Applicant: Tim Rybak; Bloomington Public Schools (ISD #271)
 Consultant: Matt Isakson; Bolton & Menk, Inc.
 Project: Normandale Hills Elementary School Chiller Addition
 Location: 9501 Toledo Avenue South, Bloomington, MN
 Applicable Rule(s): 4 and 5
 Reviewer(s): Josh Phillips and Louise Heffernan; Barr Engineering Co.

Normandale Hills Elementary School Renovations

GRADING AND EROSION CONTROL PLAN

C1.2

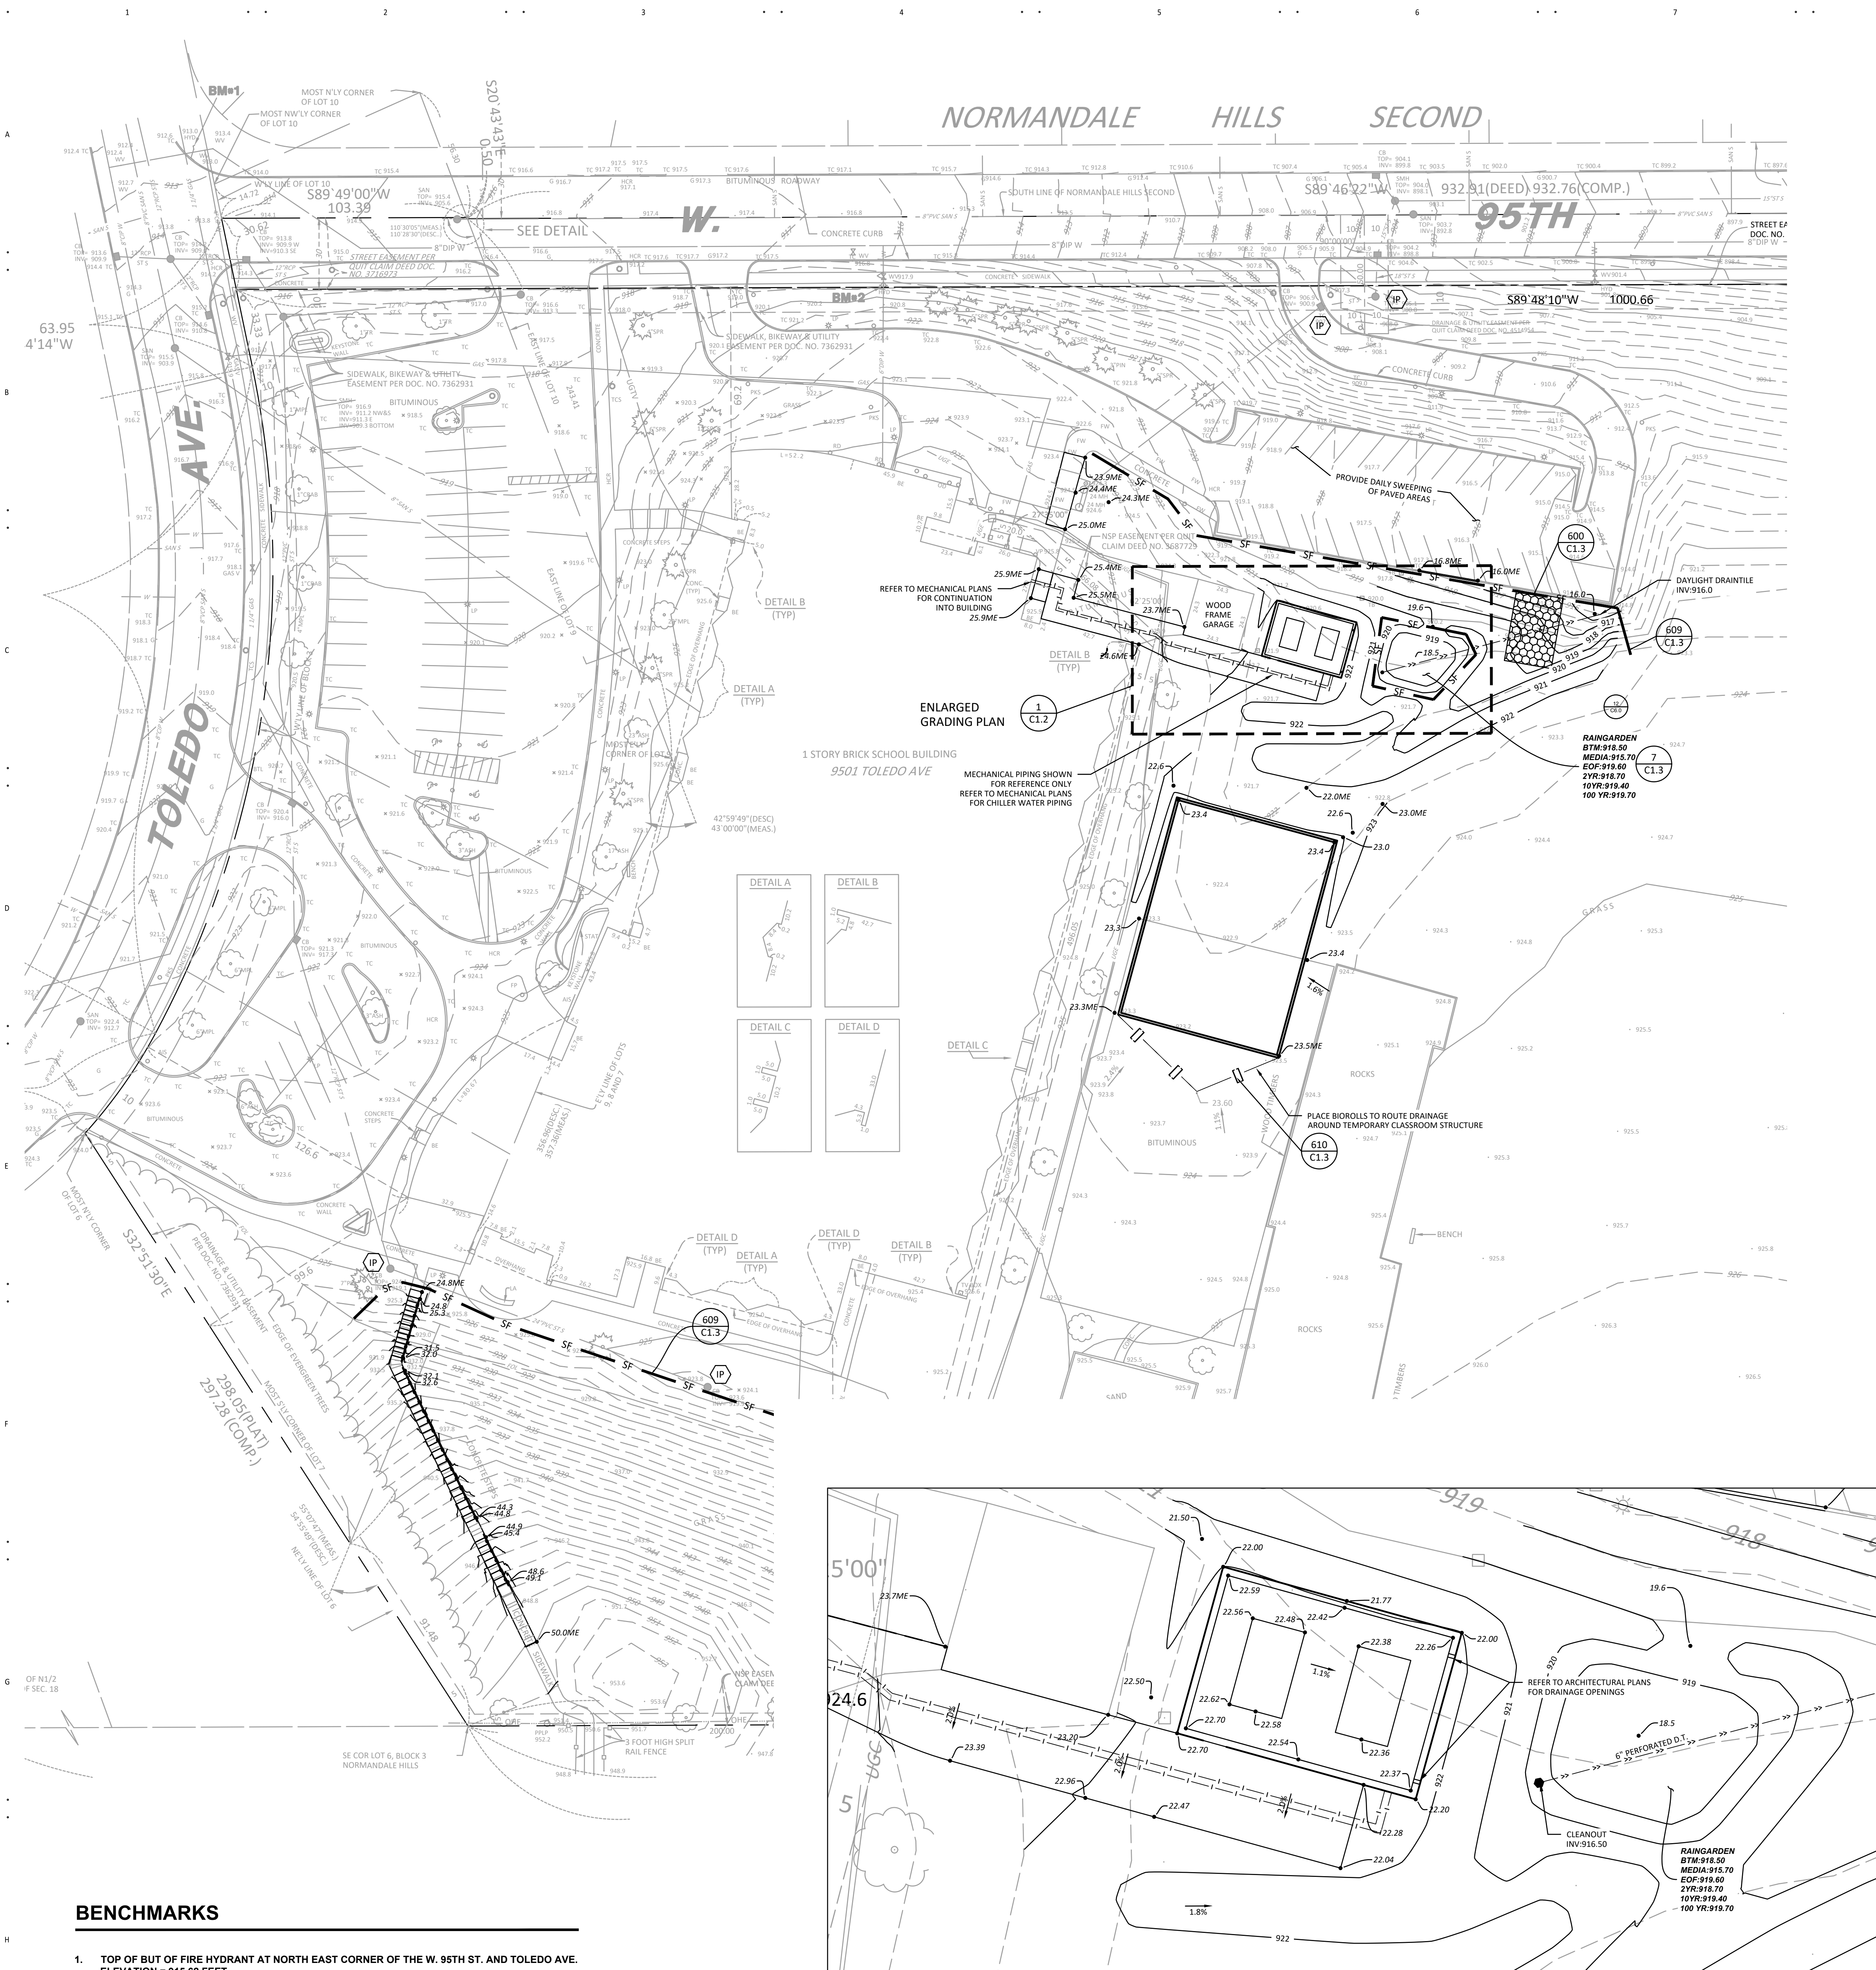
Rule 4.3.3 states that all new and reconstructed buildings must be constructed such that the low floor is at least two feet above the 100-year high-water elevation or one foot above the emergency overflow of a constructed facility. Additionally, Rule 4.3.3 states that all new and reconstructed buildings must be constructed such that no opening where surface flow can enter the structure is less than two feet above the 100-year high-water elevation of an adjacent facility. Alternatively, Appendix 4a analysis may be used to demonstrate compliance with low floor criteria. To comply with Rule 4.3.3, the following is required:

- The low floor and low opening elevations of the existing school building, proposed chiller enclosure, and temporary classroom structure must be shown on the plans. The applicant must demonstrate compliance with Rule 4.3.3 criteria relative to the 100-year high-water elevation of the proposed rain garden.
